# Access Compliance Report

## Public Rights-of-Way

Intersection ID: 9610	Main Street: BARRINGTON_DR	Cross Street: THE_PLAZA	Location: SE
ADA ID: F85677DA9287	Ramp Type: ParaDiag	Initial Pass/Fail: Pass	Overall Compliance: No
Codes/Mitigation Info/Possible Solution		Field Measurements/Component Compliance	
Severity Score: 7.75

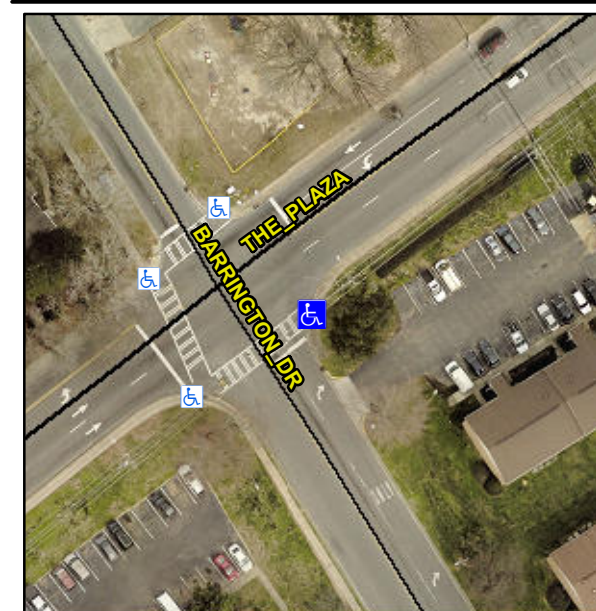
**R304.5.3, R304.2.1, R304.2.2-Perp, R304.3.2-Para, R305.2, R302.7, R302.7.2**

Compliance	Description	Data	Compliance	Description	Data
N/A	Ramp Length LT (in)	48.0	N/A	Ramp Length RT (in)	37.0
Yes	Ramp Width LT (in)	60.0	Yes	Ramp Width RT (in)	58.0
Yes	Ramp Slope LT (%)	5.6	Yes	Ramp Slope RT (%)	6.2
Yes	Ramp XSlope LT (%)	0.2	No	Ramp XSlope RT (%)	2.8
Yes	Landing Length (in)	60.0	Yes	DWS Provided?	Yes
No	Landing Width (in)	34.0	Yes	DWS Contrast?	Yes
No	Landing Slope (%)	4.5	Yes	DWS Length (in)	25.5
No	Landing X Slope (%)	2.7	Yes	DWS Full Width?	Yes
N/A	Landing Curb? (Y/N)	No	No	DWS Offset (in)	4.0
N/A	Shared Landing?	No			
No	Gutter Ponding?	Yes	Yes	Gutter Slope (%)	4.1
No	Gutter Lip Ht (in)	0.5	Yes	Gutter X Slope (%)	2.0
N/A	Painted X Walk1?	No	N/A	Painted X Walk2?	Yes
	X Walk 1 Direction	To NW		X Walk 2 Direction	To SW
N/A	X Walk 1 Width (in)	N/A	N/A	X Walk 2 Width (in)	106.0
	X Walk 1 Slope (%)	1.5		X Walk 2 Slope (%)	2.0
	X Walk 1 X Slope (%)	2.5		X Walk 2 X Slope (%)	0.2
N/A	Ramp inside XWalk1?	N/A	Yes	Ramp inside XWalk2?	Yes

**Remove & Replace Curb Ramp With Two New Directional Ramps or Equivalent. Grind Gutter Lip.**
